Hume Planning Scheme Amendment C207 and C208

Expert Witness report provided to Planning Panels Victoria

Drainage Evidence

(C208 - Property 1,2 and C207 - Property 61,64,687)

**Figure 4: Reference plan showing the key items of Melbourne Water's objection to the permit**

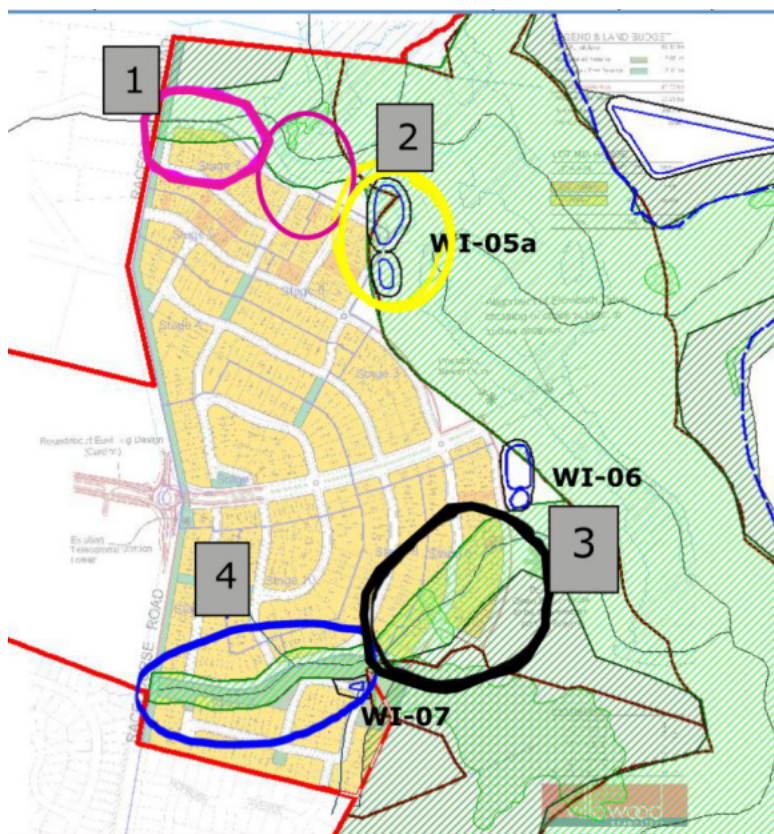
Villawood has submitted a Section 96A application for the Sherwood Heights Estate, to be considered concurrently with the Lancefield Road PSP. However in February 2017, Melbourne Water submitted an objection to the permit due to “significant discrepancies between the Sherwood Heights masterplan and Melbourne Water’s current draft DSS design”. As highlighted in Figure 5, the key items were:

1. *Lots and roads are proposed over Melbourne Water’s designated waterway corridor (pink circle). Roads and lots must be located outside Melbourne Water’s waterway corridor.*

2. Lots and roads are proposed over asset WI-05a (yellow circle). Roads and lots must not be proposed within the area required for drainage assets under the draft Devon Park DSS.
3. No provision has been made for the required waterway corridor, south-west to Jacksons Creek (black circle). A waterway and associated corridor are essential in this location (in accordance with the PSP and DSS).
4. The waterway corridor is not wide enough and terminates at a high-point in the landscape (blue circle). This is labelled linear park in the subdivision masterplan, but the required function is a drainage asset. The subdivision must make provision for this essential waterway corridor. In addition, the masterplan also shows lots that are shown backing on to the waterway in this section. This is unacceptable as per Requirement R55.
5. The subdivision must make provision for asset WI-7 (blue circle)

**Figure 6:** Change in development line boundary at Sherwood Heights

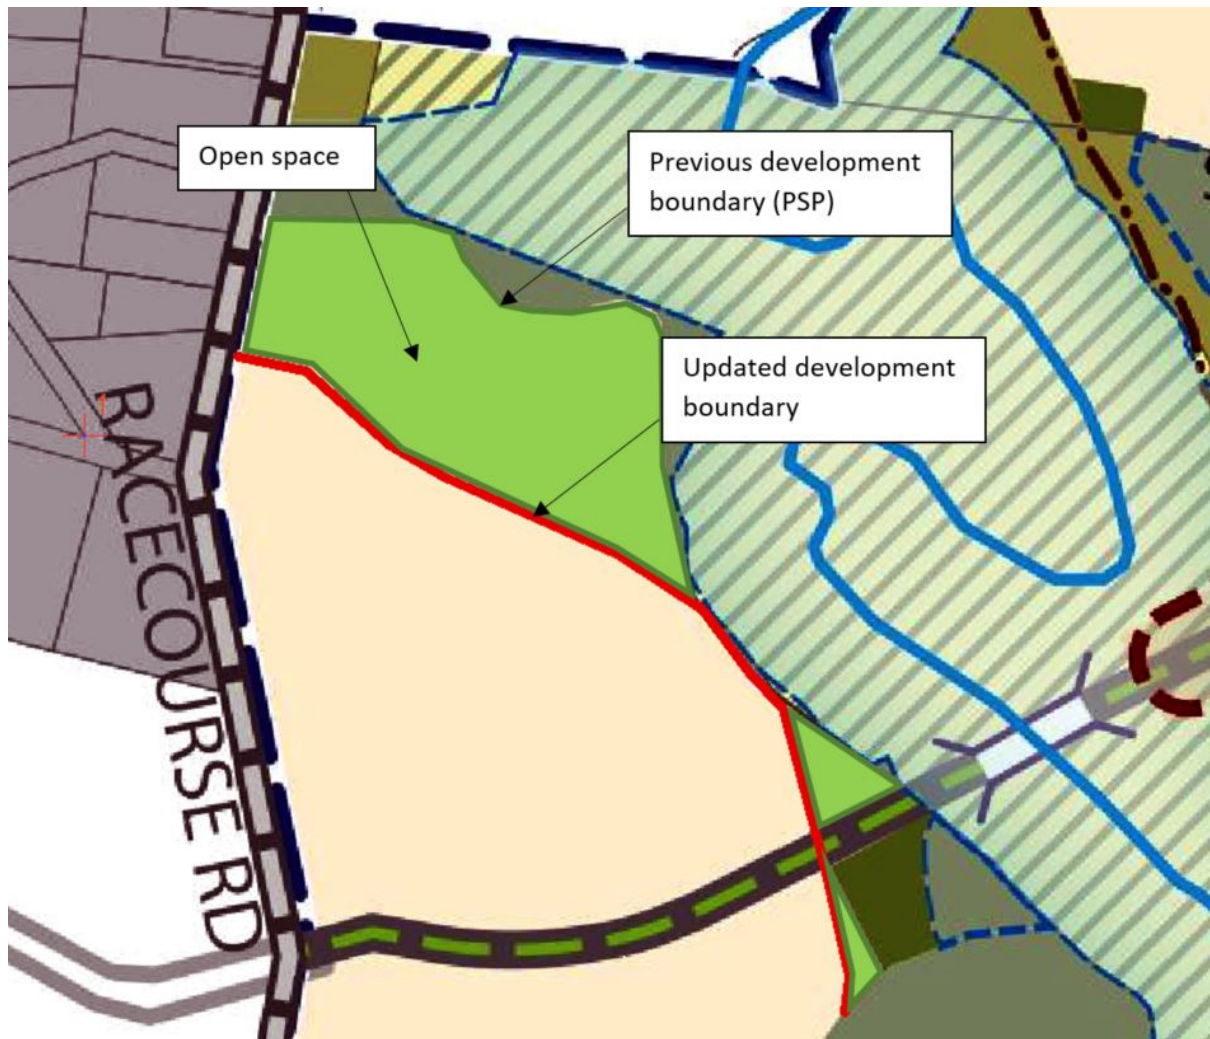
As shown in Figure 6, the proposed extent of development has been significantly reduced in the northern portion of the site. As a result all lots and roads in the north are now clearly outside of Melbourne Water's waterway corridor. Therefore in my opinion item 1 of Melbourne Water's permit objection has now been satisfied.

**Figure 8:** Alternative configuration of the wetland footprints compared to the current DSS

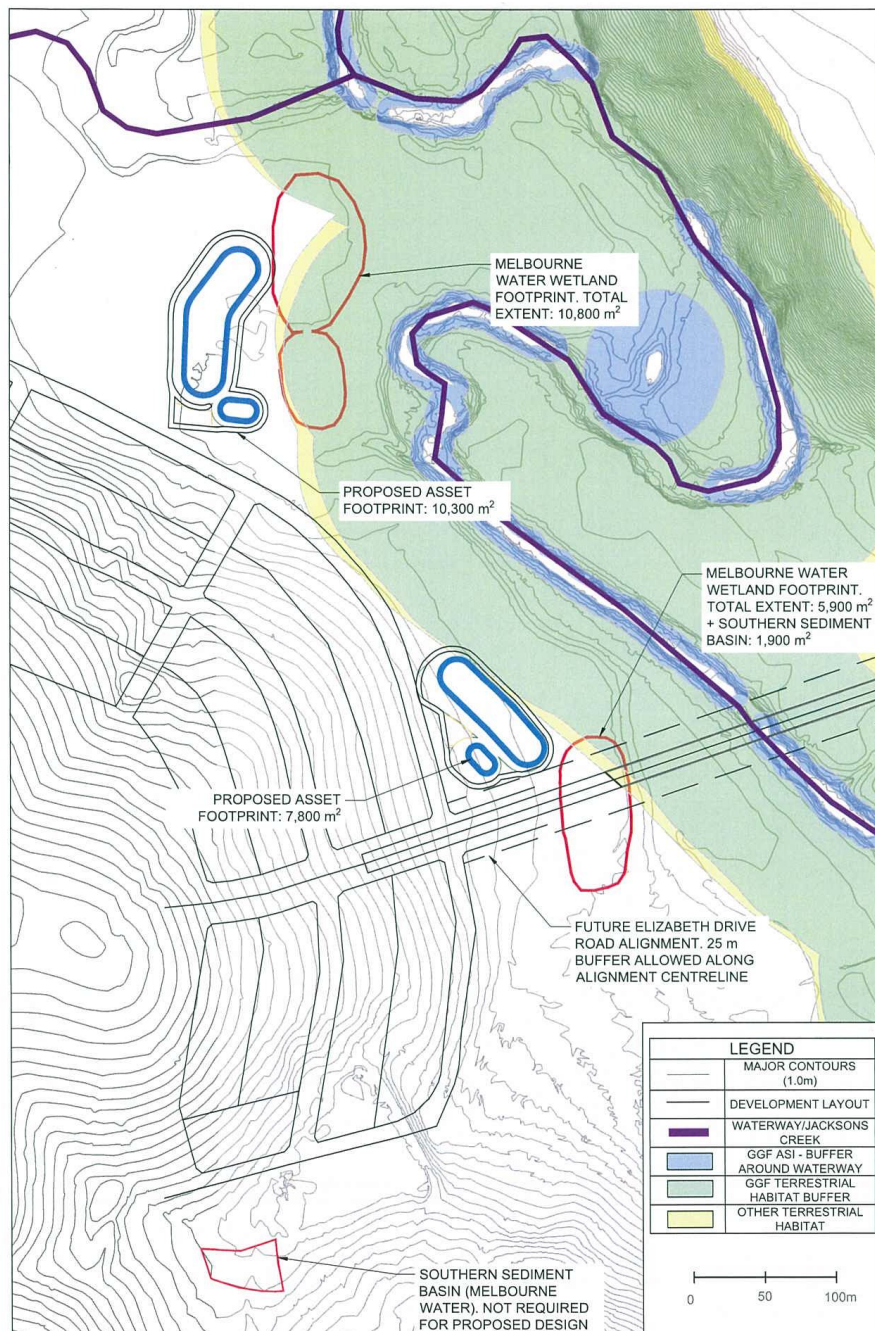
A comparison of the proposed alternative configuration of the wetland assets and the exhibited PSP (MW DSS) are shown in Figure 8.

**Figure 9:** Functional layout of the alternative configuration for asset WI-05a in the north

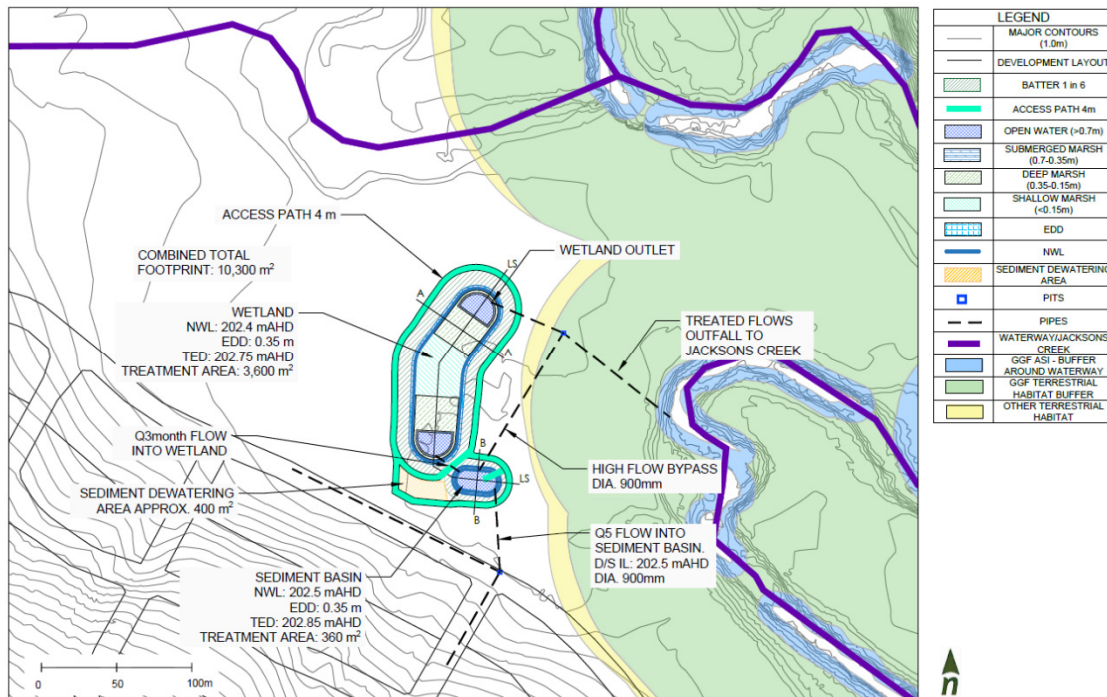
As shown in Figure 9, the proposed extent of development has been significantly reduced in the northern portion of the site. As a result all lots and roads in the north are now clearly outside of Melbourne Water's waterway corridor. Therefore in my opinion item 2 of Melbourne Water's permit objection has now been satisfied.

**Figure 10:** Functional layout of the alternative configuration for asset WI-06 in the south

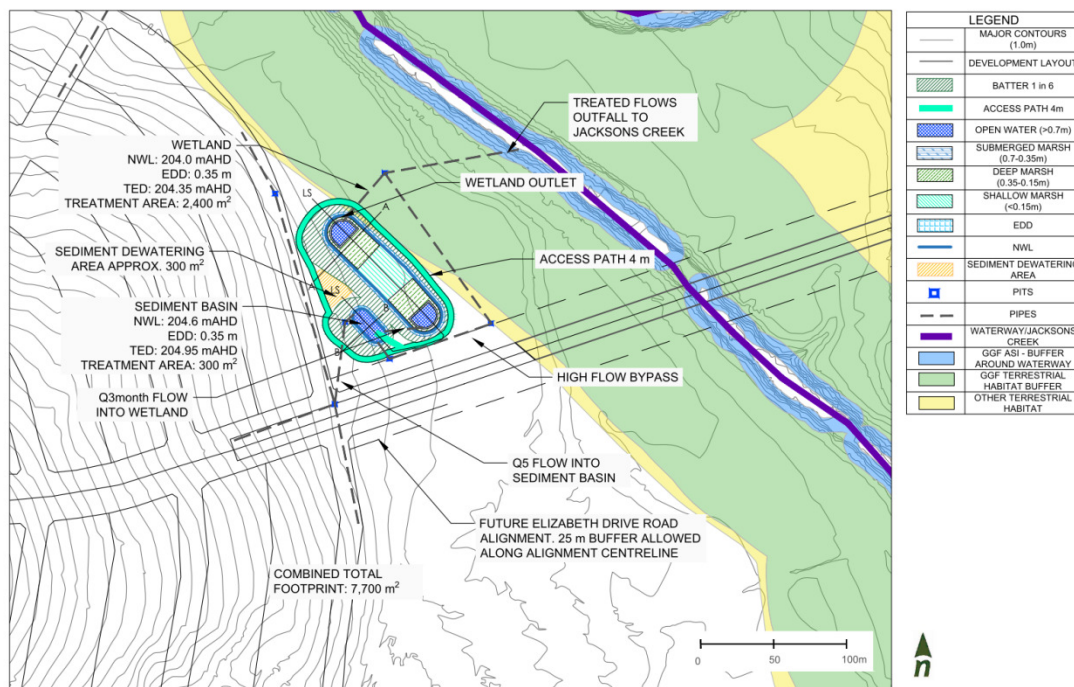
- The alternative configuration consolidates sedimentation basin WI-07 with the larger wetland asset WI-06. The PSP shows sediment basin WI-07 as an isolated asset on relatively steep topography on the southern side of the proposed waterway corridor. However topographically the consolidation of these two assets can easily be achieved by piping flows under the proposed waterway corridor. In my opinion this should not be an issue as this section of the waterway will need to be significantly modified and reconstructed due to the removal of the existing dam and the future road reserve crossing. As a result the pipe crossing can occur downstream of the proposed road and upstream of the existing dam. Consolidation allows a smaller overall footprint and one less asset for Council to manage. This is consistent with Council's submission which stated *"It is noted that the PSPs identify 57 retarding basins across the two precincts. Of these, 51 are identified as the responsibility of Council. Council has concerns regarding both the number of, and cost to Council for the ownership / maintenance of these assets.....Opportunities should be explored to consolidate these and reduce the number of assets"*.

As described above and shown in Figure 10, the sediment basin WI-07 can be consolidated with the larger wetland Asset WI-06. Therefore in my opinion item 5 of Melbourne Water's permit objection has now been satisfied.

**Figure 15:** Alternative configuration of the wetland footprints compared to the current DSS

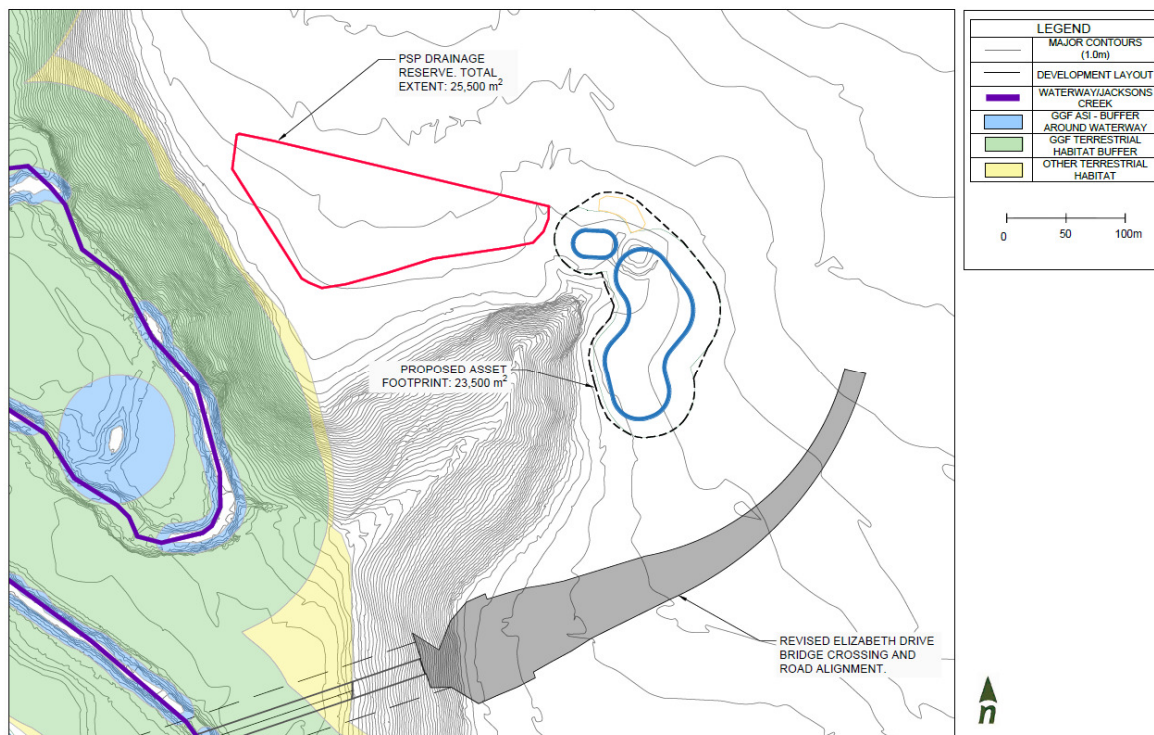
A comparison of the proposed alternative configuration of asset WI05 and the exhibited PSP (MW DSS) are shown in Figure 15. The required drainage reserve “land take” for the alternative configuration is 2.35ha compared with 2.55ha for the DSS concept.

From a “land take” perspective the alternative configuration provides a slight reduction (ie 8%) in the required drainage reserve. However in my opinion, given the alternative configuration was based on a functional design and the DSS was a concept, this difference is marginal. However I believe that the functional design has demonstrated that the alternative configuration is technically sound and feasible.

**Figure 20:** Comparison footprint of WI-04 between exhibited plan and updated DSS

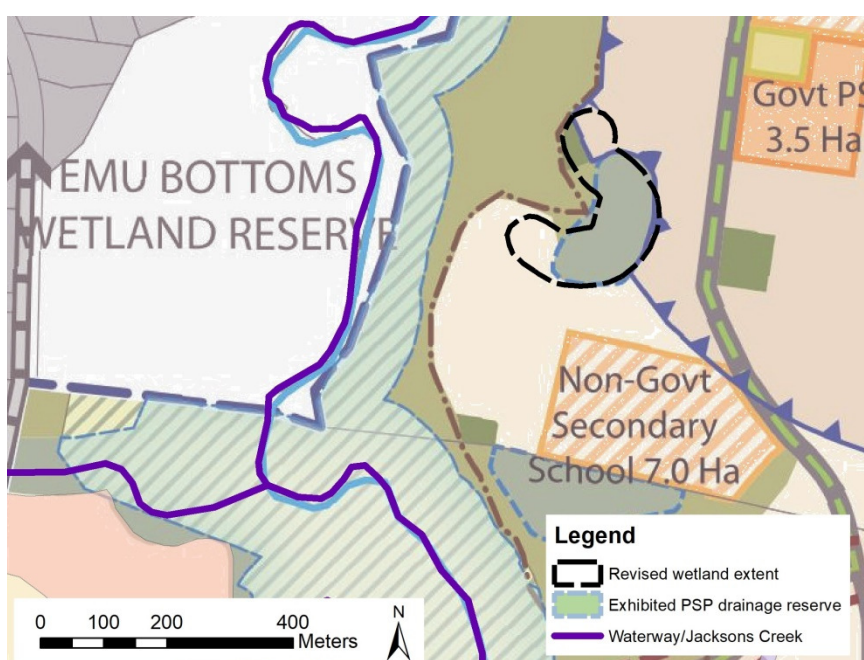
Based upon these functional designs Melbourne Water recently provided an updated plan of the drainage reserves required for the assets (refer to Figure 19). When comparing Figure 19 to the exhibited PSP (see Figure 18) it is clear that the footprint has significantly increased. This is highlighted in Figure 20 which shows that the footprint for asset WI-04 has increased by 54%.

The above information was requested of Melbourne Water (ie functional design plans and functional design reports) but it had not been received at the time of writing this evidence report. It is possible that the proposed footprints are appropriate, however it is not possible to make an informed opinion regarding the “reasonableness” of these complex systems without the detail of functional design information that they were based upon.

**Figure 23:** Wetland/retarding basin asset WL-15 – DSS reserve versus Villawood 96A layout

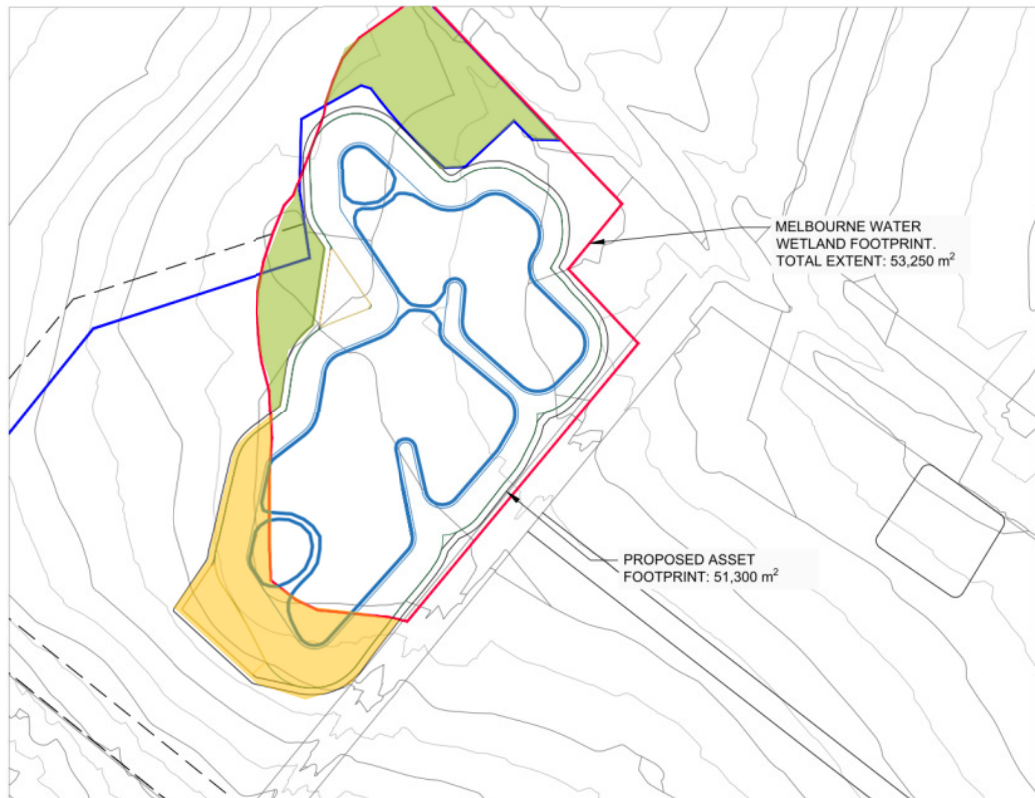
- “Based on modelling and calculations undertaken by Melbourne Water, the area of land the (sic) required for WI-15 is 5.33 Ha (as shown in Table 9 of the exhibited Sunbury South PSP). Based on the application submitted, no provision has been made for the required asset in the subdivision masterplan.”

The proposed solution is demonstrated in Figure 23 below. The drainage reserve area shaded green in Figure 23, as shown in Melbourne Water's DSS concept design, has been redistributed to the south west (shown in orange) in the proposed wetland/basin site. This alternate wetland/retarding basin footprint accommodates Villawood's 96A permit boundary whilst achieving Melbourne Water's objectives for the original asset.

A comparison of the proposed alternative configuration of the wetland assets and the exhibited PSP (Melbourne Water DSS) are shown in Figure 23. I note that in my experience it is common for designs at the permit application stage (completed to a functional standard) to be more advanced, and hence differ slightly from higher-level concept designs completed during establishment of the DSS.

**Figure 24:** Plan view of designed wetland structure

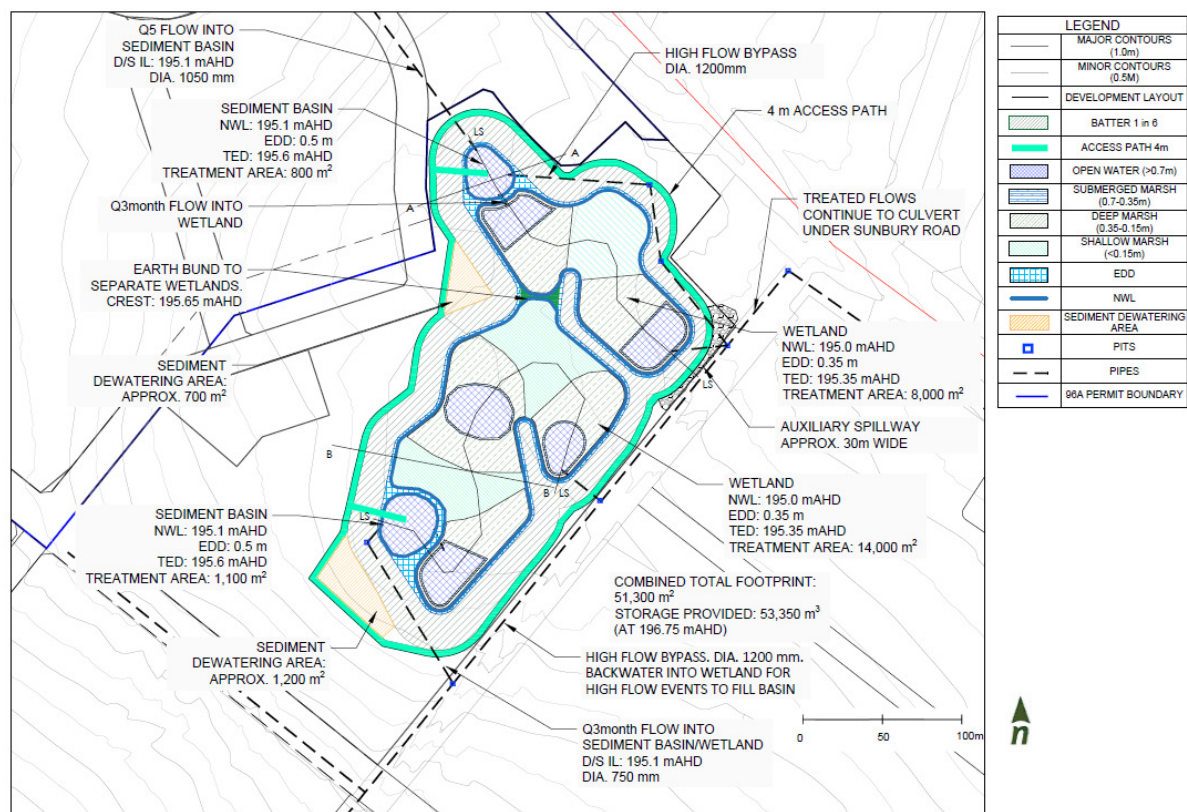
As described above and shown in Figure 24, the total revised treatment asset footprint can be accommodated with Villawood's 96A permit boundary. The revised asset meets Melbourne Water's original objectives for Shepherds Lane DSS in providing water quality and quantity treatment. Therefore in my opinion the original objection raised by Melbourne Water's has now been satisfied.

**Figure 27:** Wetland/retarding basin asset WI-12 – DSS reserve versus Villawood 96A layout

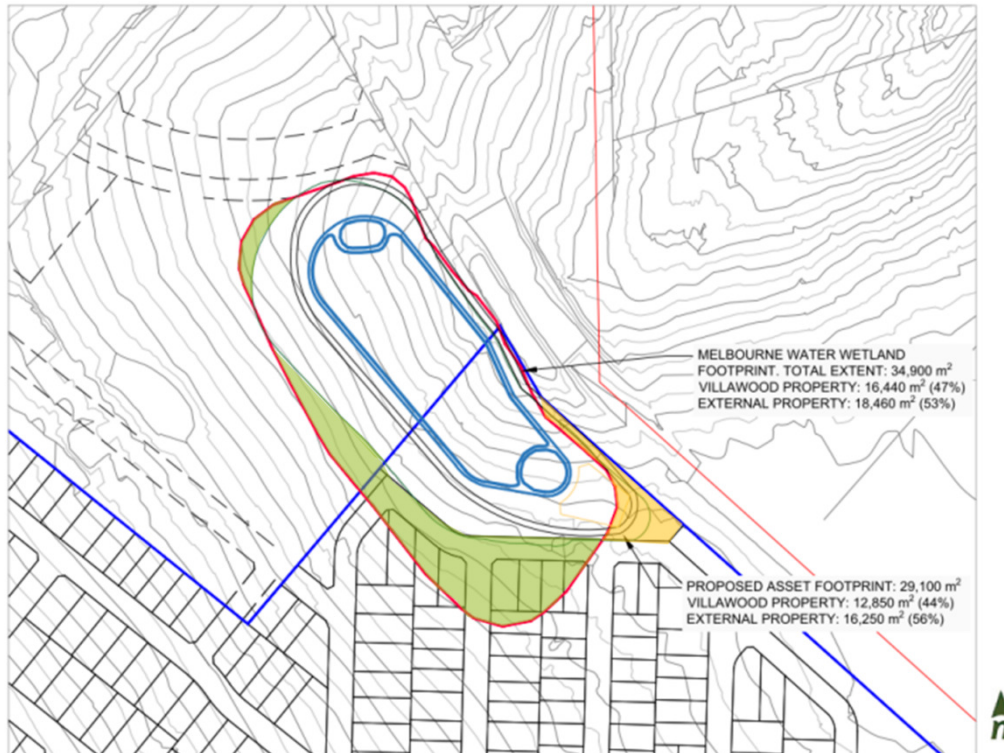
A comparison of the proposed alternative configuration of the wetland assets and the exhibited PSP (Melbourne Water DSS) are shown in Figure 27. Under the reconfiguration, the "land savings" have been distributed across the two landholdings (shown in green). The outcome is approximately a similar percentage spilt of the drainage reserve on each landholder as in the original DSS. Some of the drainage reserve area shaded green, as shown in Melbourne Water's DSS concept design, has been redistributed to the east (shown in orange) in the proposed wetland/basin site.
